Commonwealth Edison Company  
Braidwood Generating Station  
Route #1, Box 84  
Braceville, IL 60407-9619  
Tel 815-458-2801

November 18, 1999  
BW990080

Braidwood Station, Units 1 and 2  
Facility Operating License Nos. NPF-72 and NPF-77  
NRC Docket Nos. STN 50-456 and STN 50-457

Subject: Submittal of Changes to Emergency Plan Implementing Procedures

# OSC SUGGESTED LAYOUT

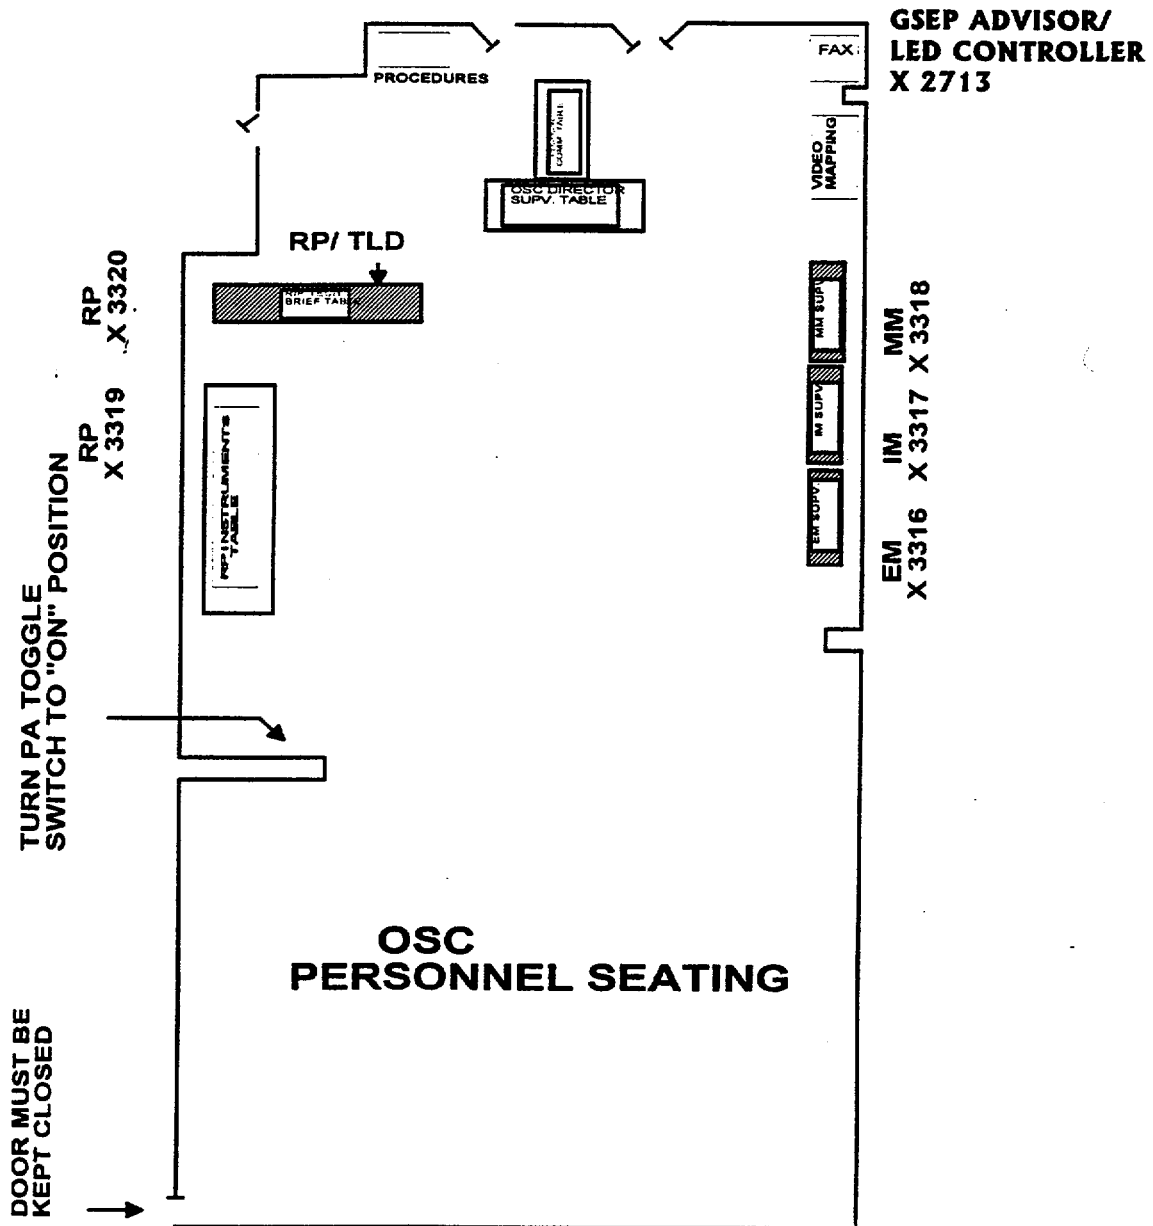
1. BwZP 3000-1A2, "OSC Suggested Layout"

The phone number for the Datalink phone was changed from x2285 to x3335.

Command and Control X 3338  
Datalink X 3335  
OSC Director X 2285  
OSC Supervisor X 2947
